MEMORANDUM

REVIEW TYPE: Preliminary Plan Review

PROJECT NAME: Long Branch Medical Building

CASE #: 120060240 (Formerly 1-06024)

PRELIMINARY PLAN

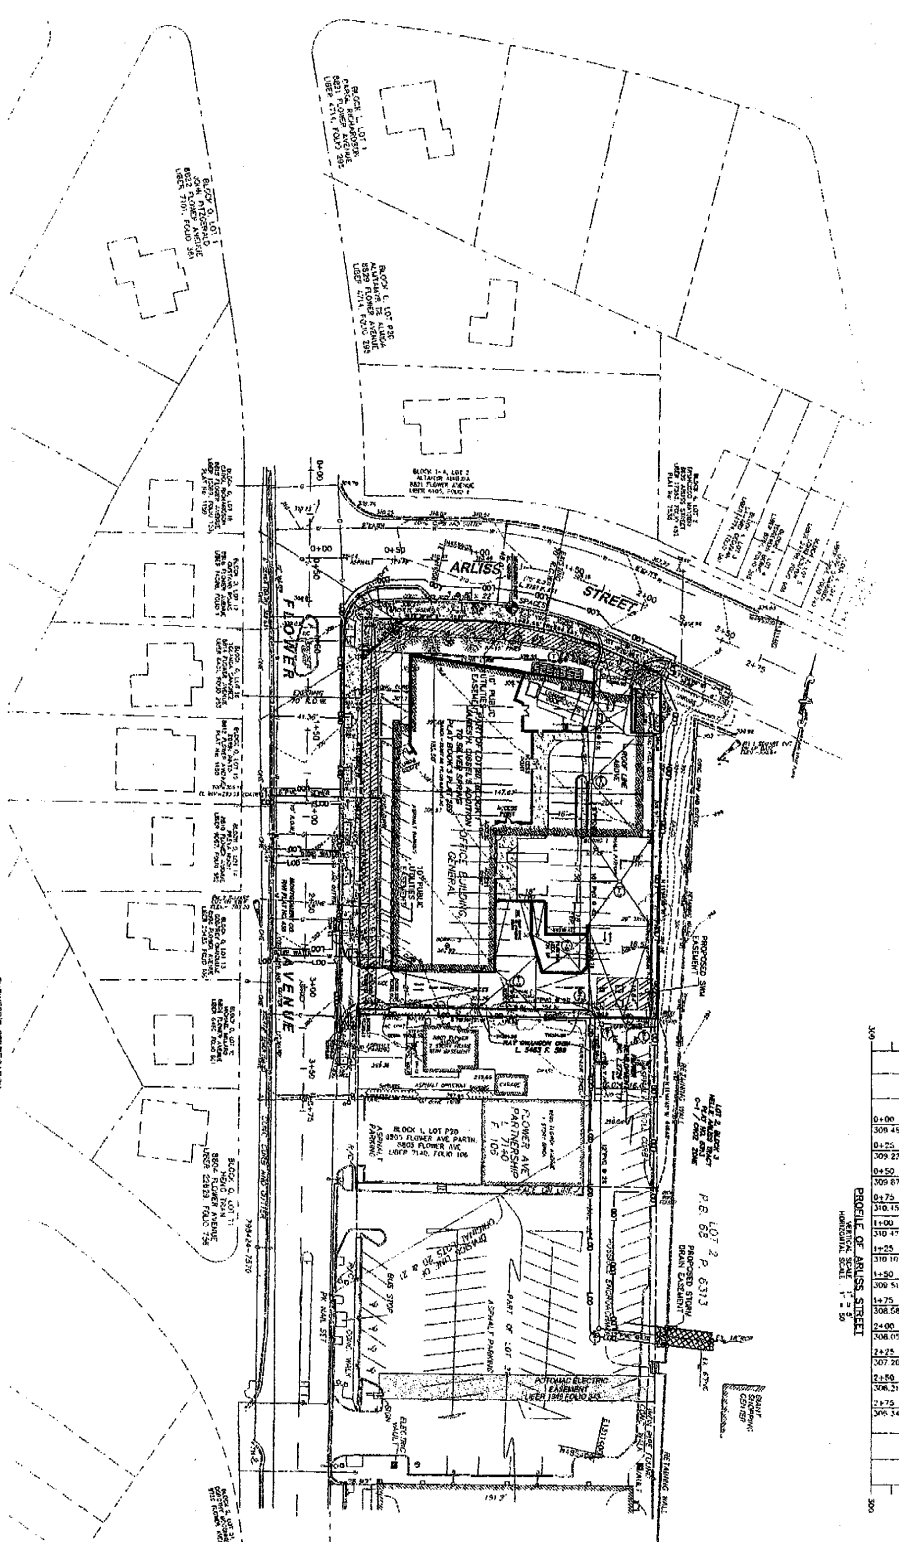
This is a preliminary plan application to create one (1) lot for the construction of a 55,800 square foot office building (Attachment B) which is slightly less square footage than could be constructed per the approved traffic study. This preliminary plan is being reviewed concurrently with Site Plan #8-20060080. Access to the site will be directly from Arliss Street and Flower Avenue.

Setback reductions are permitted by the CROZ, but no setback reductions have been requested. Instead, the building has been pushed back further than the required 10' setback along the two street frontages, providing an opportunity for additional landscaping along the edges. The proposed building setback along Flower Avenue aligns with the face of the Flower Theater down the block. As illustrated on page 40 of the Master Plan (Attachment 3), the Plan contemplated new buildings on this site that are located close to the street.

The streetscape recommendations in the Master Plan include a shared use (pedestrian and bicyclist) sidewalk along Flower Avenue. The application proposes a 15'-wide sidewalk (11' clear at the tree pits) that will accommodate both pedestrians and bicyclists. The shared-use sidewalk will facilitate access to the proposed building as well as other uses on the block. A Class III bike route (signed, shared roadway) is also recommended on Flower Avenue. The site plan includes bike storage facilities at an appropriate location.

An existing curb cut on Flower Avenue near the corner of Flower Avenue/Arliss Street will be removed to improve safety. Vehicular access points will be limited to a single entrance on Flower Avenue and a single entrance on Arliss Street—away from the Flower Avenue/Arliss Street intersection, at opposite corners of the site. Drivers who cannot find surface parking behind the building will be able to go directly into structured parking. A covered patient drop-off area that is internal to the site will remove this function from adjoining roadways.

STAFF RECOMMENDATION: Approval, pursuant to Chapter 50 of the Montgomery County Subdivision Regulations, and subject to the following conditions:

- 1) Approval under this preliminary plan is limited to a 57,900 gross square foot office building.
- 2) No clearing or grading prior to site plan signature set approval.

- 3) Final approval of the location of building, on-site parking and site circulation, will be determined at site plan.
- 4) A landscape and lighting plan must be submitted as part of the site plan application for review and approval by technical staff.
